2000 Corvette: Service Bulletin: Left Headlamp Door Does Not Stay Closed

Number: 00-08-42-002

Subject: Left Headlamp Door Does Not Stay Closed (Shim Headlamp Door Motor/Actuator and Replace Insulators)

Model Year: 2000 Chevrolet Corvette

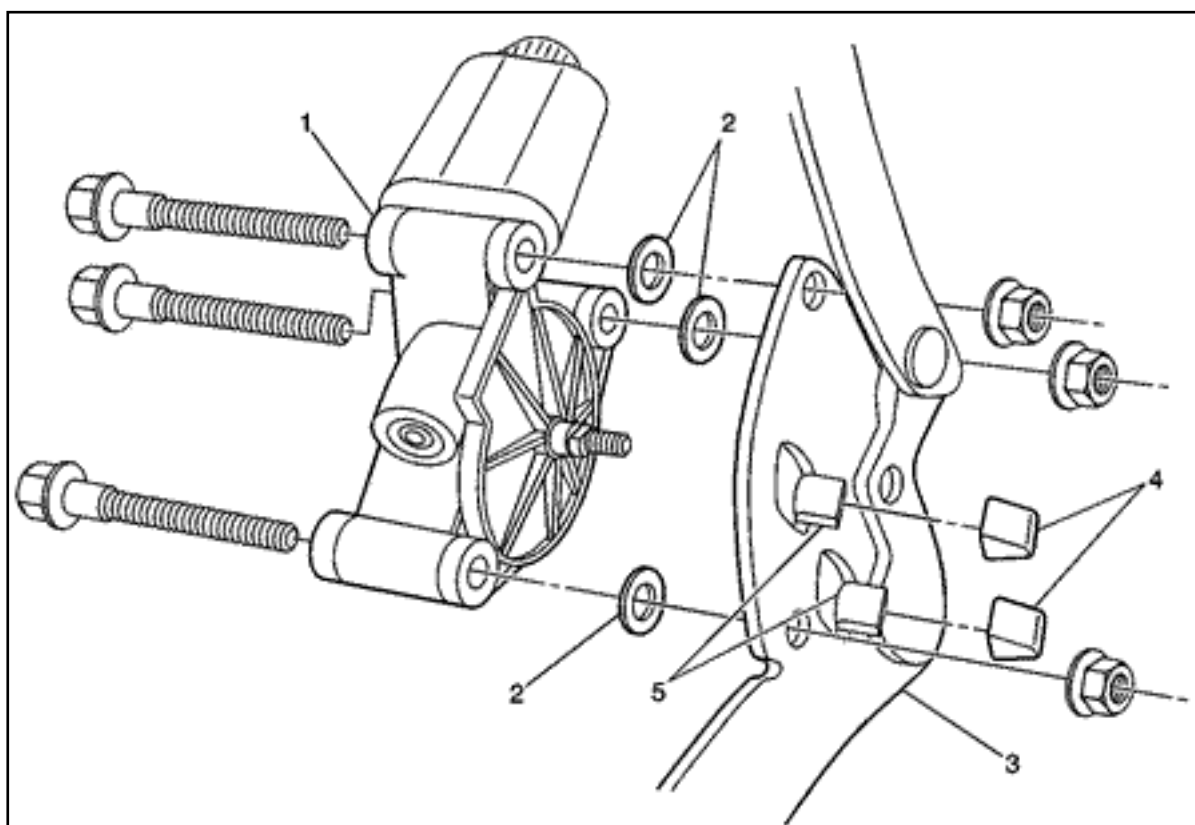
Some customers may comment that the left front headlamp door does not remain closed after the headlamps are turned off. Others may comment that the left headlamp door closes when the headlamps are turned off, but then reopens. In either case, the right headlamp door operates properly.

The following information applies to the left front headlamp door motor/actuator only. It does not apply to and should not be performed on the right front headlamp door motor/actuator.

Install one washer (2) between the left headlamp door motor/actuator (1) and the mounting bracket (3) at each of the three attaching bolt locations. Also replace the insulator (4) on each of the two mounting bracket travel stop tabs (5) as shown. For information on headlamp motor/actuator removal, see the Headlamp Motor/Actuator Replacement procedure in the Lighting sub-section of Body & Accessories in the appropriate Service Manual.
